Planning Commission Staff Report  
Council Chambers  
December 4, 2018 1:30pm

**7. APPLICATION: Arrowleaf Apartments | Development Plan**

Project Number: 201810290047

Proposal: A development plan for 28-unit apartment building on a 4.77-acre site.

Site Plan

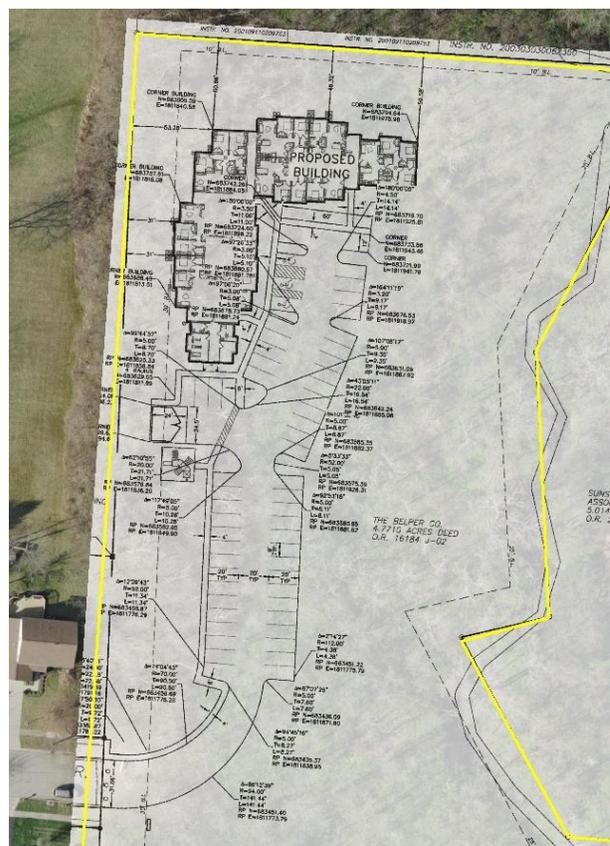
The site is proposed to be accessed from a single point at the terminus of Shirlene Drive. The proposed access drive will match the width of Shirlene Drive (30-feet) at the site's entrance, then narrow to 20-feet further into the development. Staff typically recommends that all drive aisles be a minimum of 24-feet in width; however, staff is supportive of the proposed drive due to the constraints of the site, including the 100-year floodplain and the Stream Corridor. Parking is proposed on both sides of the entrance drive leading up to the building and the proposed building will be located in the northwest corner of the site. Sidewalks are proposed along the building and the western side of the parking lot and are proposed to connect to the existing sidewalk on the north side of Shirlene Drive. A community playground is also proposed on the site, to the south of the building.

A vegetated retaining wall is proposed along the eastern side of the parking lot, adjacent to the stream. The plans show parking blocks for all parking spaces adjacent to the retaining wall, however, staff has concerns that parking blocks will not adequately protect vehicles from the steep drop to the stream corridor to the east and recommends reinforced fencing, per standard drawing C-GC-96 along this portion of the parking lot.

1. Reinforced fencing per standard drawing C-GC-96 shall be installed along the eastern row of parking where adjacent to the proposed retaining wall.
